VANDERBURGH COUNTY SURVEYOR
Room 325 Civic Center Complex
Evansville, IN 457708
812-435-5210

NOTICE OF PLAN INSUFFICIENCIES

NORTHWOODS CHURCH

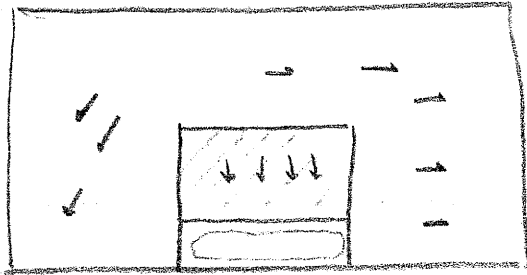
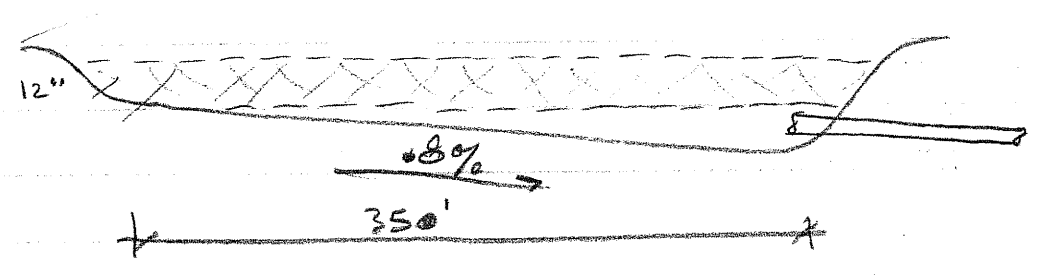
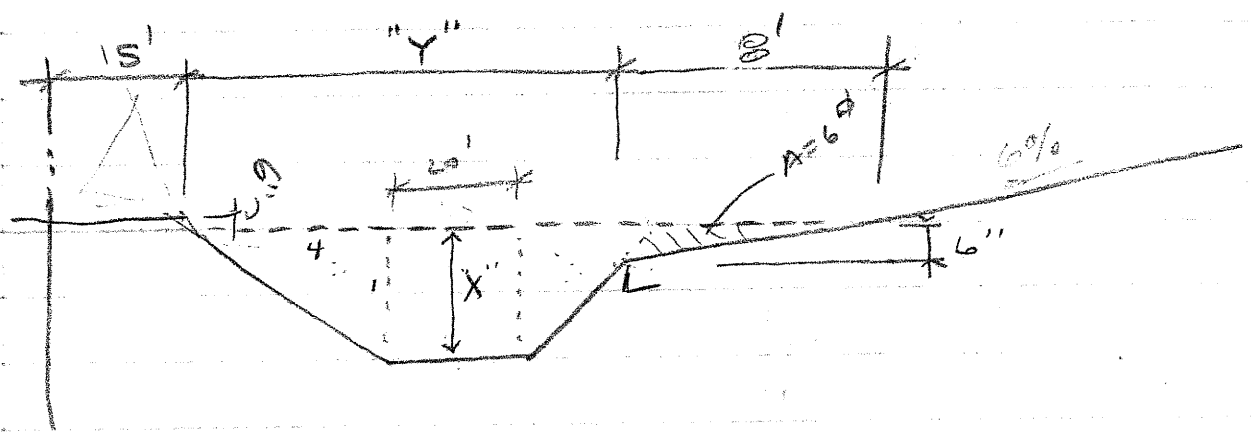
7. There is no size given for the primary discharge pipe from the detention basin.
8. There is no proof given for the adequate sizing of the overflow swale from the basin to the roadside ditch. In other words, will the swale handle the heavier rainstorms without overflowing onto the property to the south?

11. The calculations submitted with the plan do not appear to take into account the entire project site and existing conditions across the entire site. Revise the calculations to reflect all existing and proposed surface conditions.
